DOCKET NO. 50-185

AMENDMENT TO FACILITY LICENSE

Amendment No. 4
License No. R-93

ENCLOSURE TO LICENSE AMENDMENT NO. 4

FIGURE 1

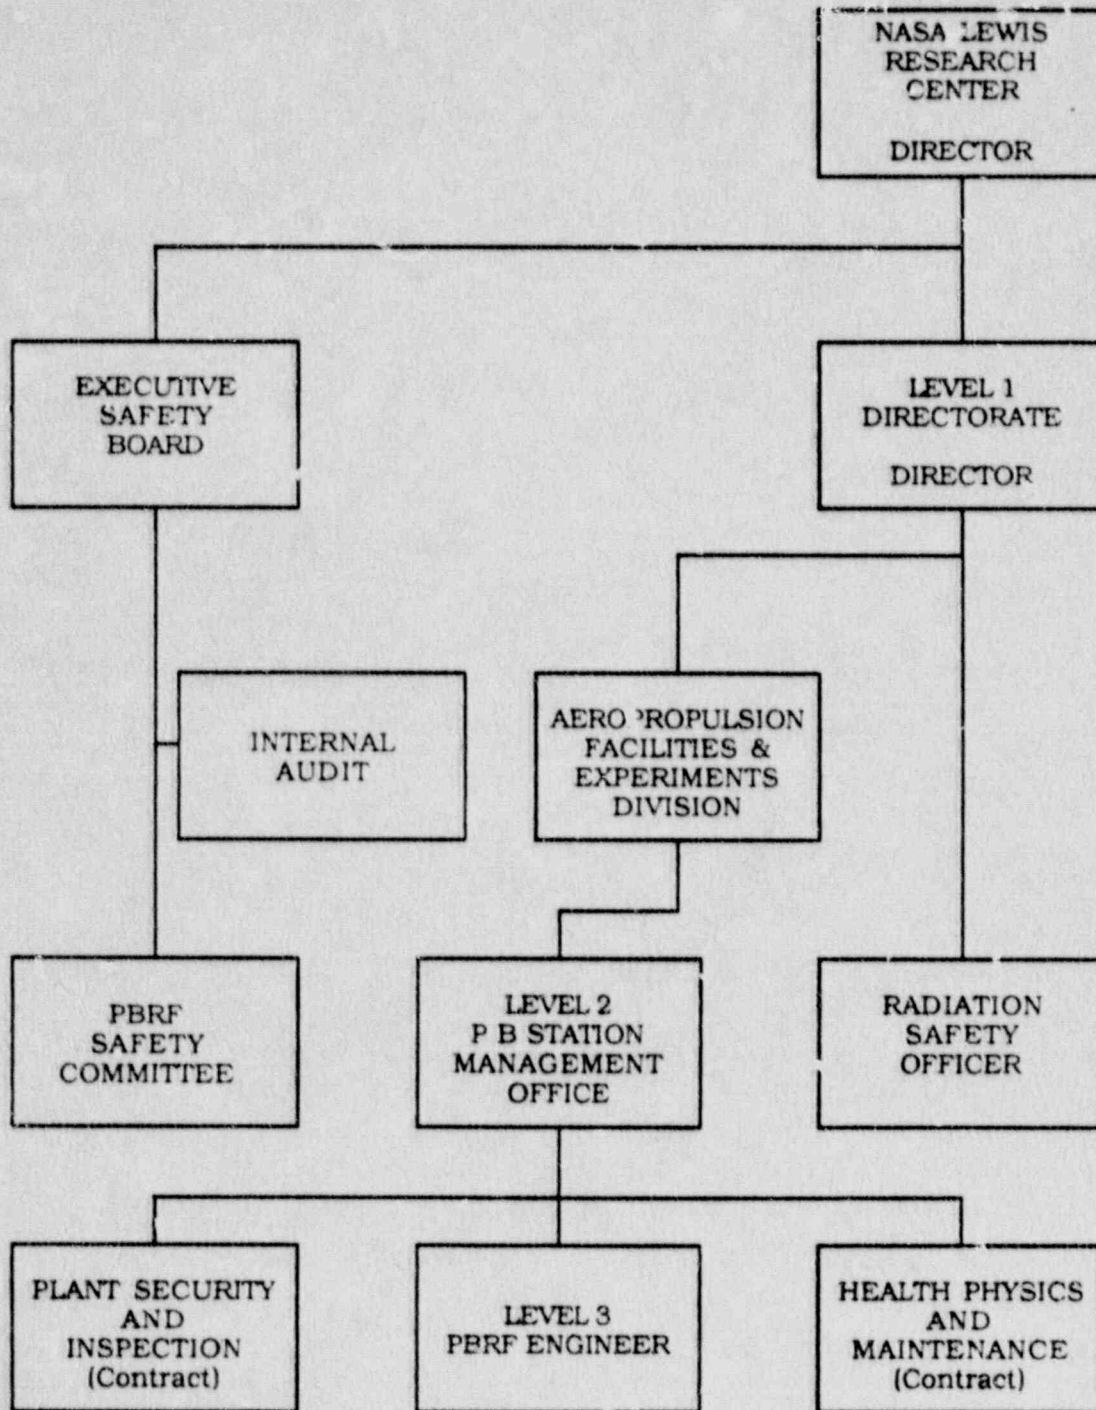
NASA shall provide whatever resources are required to maintain the MUR in a condition that poses no hazard to the general public or to the environment. Figure 1 charts the generic organization.

3.1.1 Level 1 Directorate

The Director shall be responsible for assuring compliance with the reactor facility's license and for providing regulatory reports and correspondence. He shall have overall responsibility for the protected safe storage of the MUR.

3.1.2 Aeropropulsion Facilities and Experiments Division

This Division shall provide the resources to maintain the MUR in protected safe storage.
